ADDENDUM NO. 1
to
BIDDING/CONTRACT DOCUMENTS
for
RIDGEWAY RECREATION CENTER #21-63.01
IN
FAIRFIELD COUNTY, SOUTH CAROLINA

TO: All Prospective Bidders and Subcontractors DATE: May 4, 2022
DELIVERY: E-Mail & ICE file share site (Box)

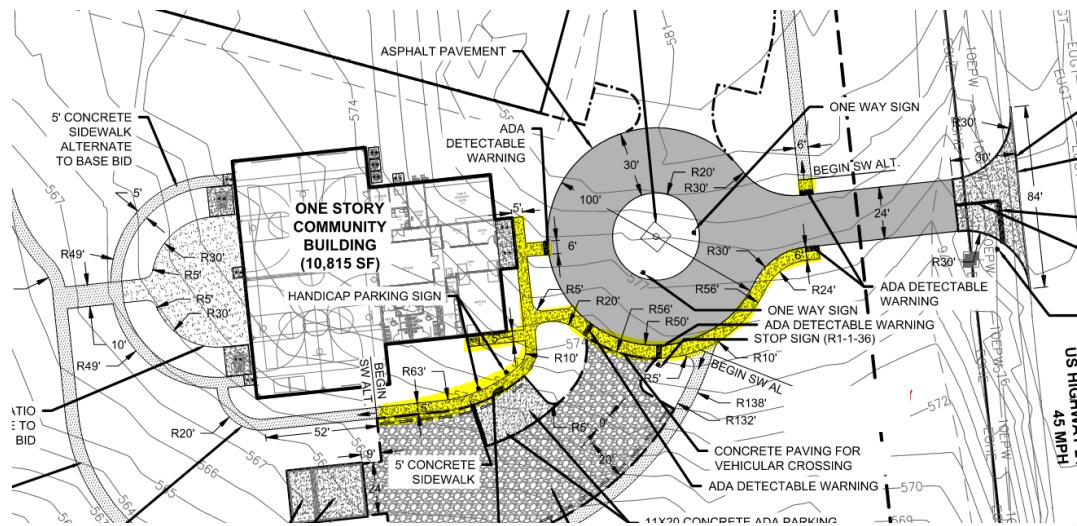
22. **Question:** The plans show alt concrete sidewalk. The spec regarding Alt #1 says concrete in lieu of stone walking path in base bid. There is no detail as to depth of stone. Are we correct to include 4" deep stone walking path in Base Bid? *Response:* Refer to the revised description of Alternate 1 in the changes to specifications in this Addendum, and to Sheet C2.01. There is limited sidewalk, equipment pads, and door stoops in the base bid. The alternate is all the additional walkways and patio sidewalk/concrete. See overlay / highlighted excerpt below for Base Bid walkway limits.
